UNITED STATES PATENT AND TRADEMARK OFFICE

10/813,589

Office Action Summary	Application No. 10/813,589	Applicant(s) PAUL ET AL.	
	Examiner Michael B. Shingleton	Art Unit 2815

DETAILED ACTION***Claim Rejections - 35 USC § 103***

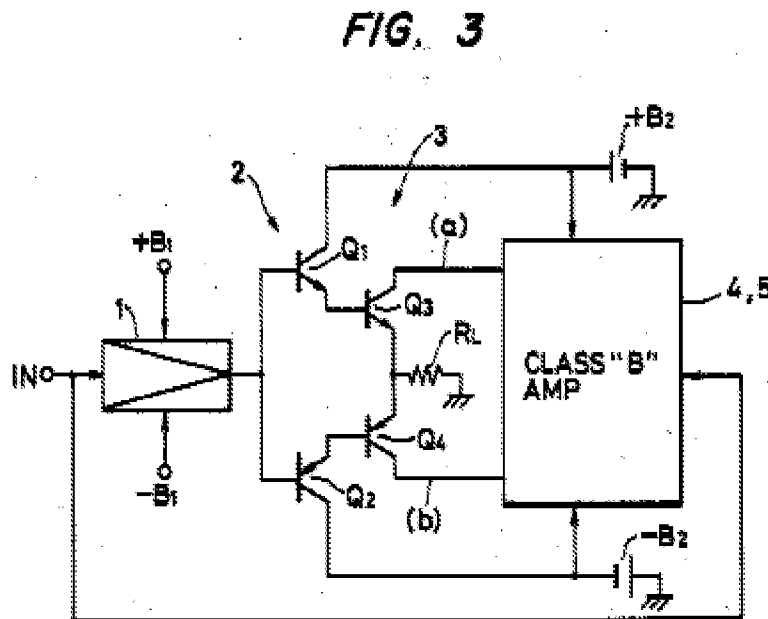
Figure 3 and the relevant text of Koinuma disclose a power amplifier arrangement and method of providing an amplifier with a preamplifier 1 (input stage) and an output stage (2 and 3) that is supplied with two different power sources (B_1 and B_2). The voltage B_2 is of a greater magnitude than that of B_1 . (See column 3, around line 36)

Figures 2 and 3 of Dudley.

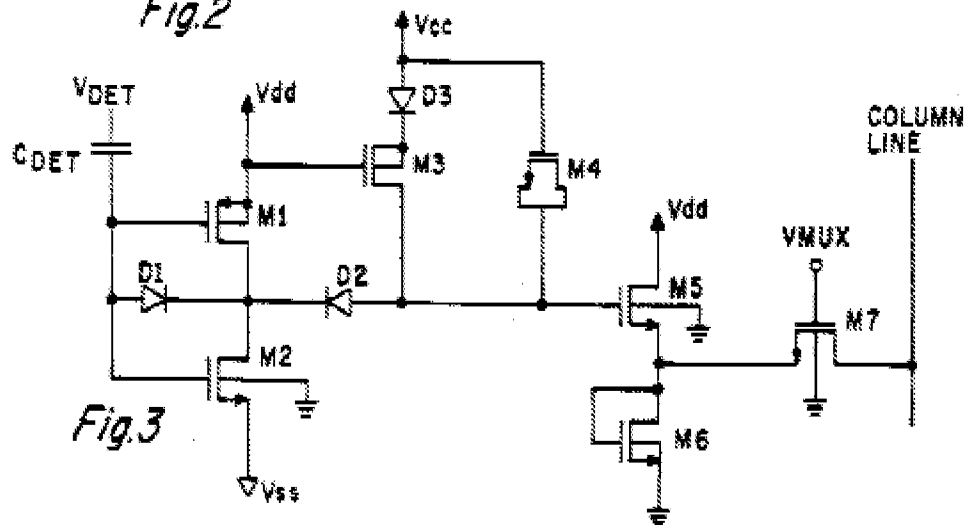
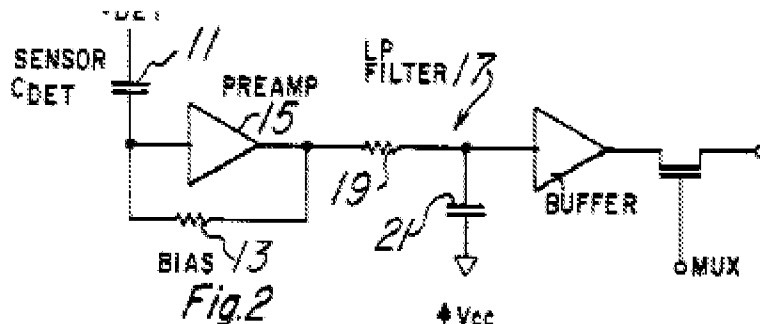
As to the CMOS input stage, Koinuma is silent on the exact construction of this stage. This is evidence that a conventional amplifier stage could be used. A specific structure that would be required other than the conventional is not recited and all Patents are presumed valid. 35 USC 282. Dudley in Figures 2 and 3 specifically recites that one conventional preamplifier stage is one that uses CMOS technology and thus that would inherently include FET structure.

Accordingly, it would have been obvious to one of ordinary skill in the art at the time the invention was made to replace the generic amplifier of Koinuma with a CMOS based unit because as the Koinuma reference is silent on the exact structure of the preamplifier stage one of ordinary skill in the art would have been motivated to use any art-recognized equivalent preamplifier structure such as the CMOS based structure of Dudley.
